Air Pollution Control District
San Luis Obispo County

SUBJECT: Recirculated Draft Environmental Impact Report (RDEIR) for the Phillips 66
Rail Spur Project

Attachment A - Detailed comments on Specific Sections of the RDEIR

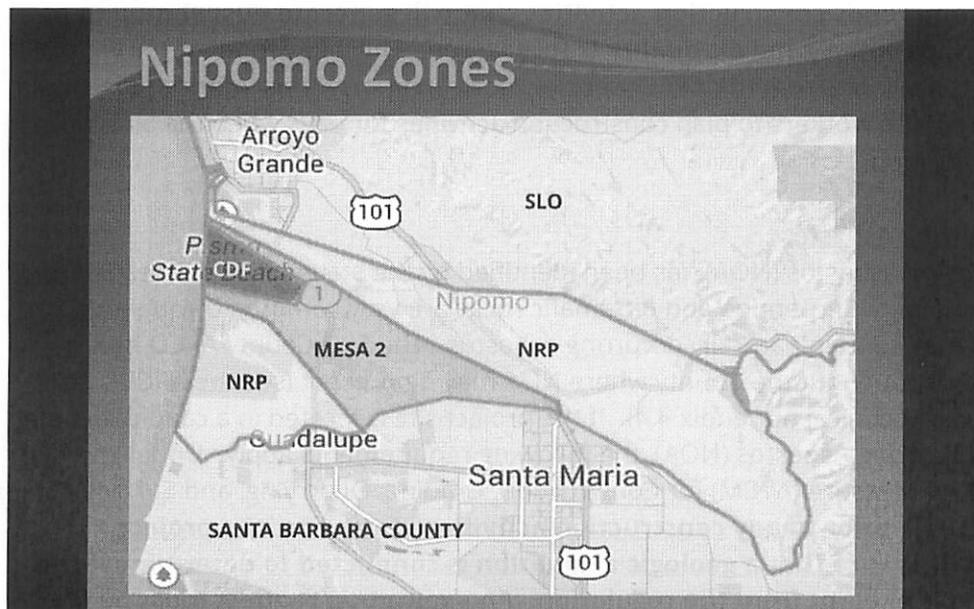
The project is located in an area that is impacted by periods of high particulate matter concentrations. The APCD has been investigating the source of the high particulate matter concentrations on the Nipomo Mesa for the past decade. Several studies performed by the APCD in the Nipomo Mesa area have shown the source of the elevated particulate matter (PM) pollution to be windblown dust from the open sand areas of the Oceano Dunes State Vehicular Recreation Area (SVRA), and that emissions are increased by off road vehicle activity. The studies provided a comprehensive picture of the characteristics of a typical dust event.

To keep the public informed of periods of deteriorating air quality, the APCD provides a daily air quality forecast for SLO County. SLO County is partitioned into nine air quality forecast zones, and an air quality forecast for a six-day period is provided for each zone. In the Nipomo Mesa area, there are four forecast zones as shown in the map below, and are named CDF, MESA2, NRP and SLO:

The darker colors in the map signify the location of the greatest dust impacts during a typical blowing dust event. The public can experience adverse health impacts in areas with blowing dust.

The following Environmental Setting should be should be noted that the vertical coastal access section of the RDEIR.
